Customer: RALEC KUNSHAN		Date: 26-May-16	Time: 14:30
Participant From Maruwa	Participant From Organizer	Report To	
1. Mr Ogawa MM MD	1. Mr Spring R&D Chief	1. Mr.Anthony,Mr.Ogawa	
2. Mr Takimoto Shanghai Sales	2. Ms Lee IQC SUPV	2. Mr.Seeni,Mr.Naga,Mr.Sinna	
3. Mr Matsumoto JM Sales	3. Mr Gao IQC Chief	3. Mr.Theva,Mr.Shahrudin,Mr.Fauzi	
4. Sivakumar MMSB QA	4	4 Mr. Matsumoto	
5. Ronny Fang Shanghai Sales	5.	5.

RALEC facing 2 technical problem

1. RA12-4

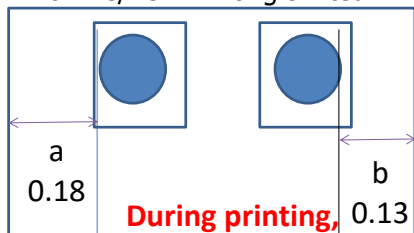
Slit line width unbalance

1st Slit & 2nd Slit shows the width imbalance. Potential Failure is

a. Slit's V Groove different size

1st Slit

Centre slit

=> Mould 1st slit repaired after pressing some qty

=> Noticed shedder mark on product

This causes need to be checked before concluding

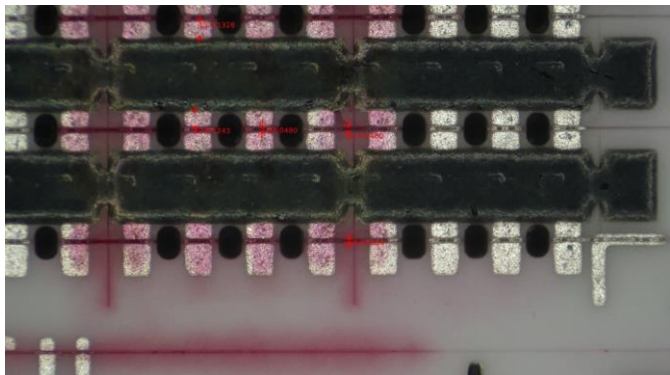
No	Complaint / Request	Product	Image	Details	MARUWA Comment	PIC	DATE
1	Slit width NG	RA12-4		Slit size different compare to the standard size. Standard: 40u Actual: 110u Failure % : 30%	Received NG Sample and will review the NG Suspected: a. Mould overshoot b. Slit unbalance - 1st slit repaired	Mr Izumo Mr Naga	ASAP
2	Lot No indication	All product			Maruwa will include small label on bundle from April 16 shipment onwards	Mr Peter (warehouse)	April 2016 shipment
3	Printing unbalance	MA02-2C MA02-4C		After printing, printing area no balance between the hole.	Need to confirm the thru hole shifted spec from 30u to 20u	Mr Muto Mr Naga	ASAP
4	Angle (+/-)	7910M		5K Sample evaluated => Result OK Request : 50kpcs	Result OK	Mr Nazli	June'16
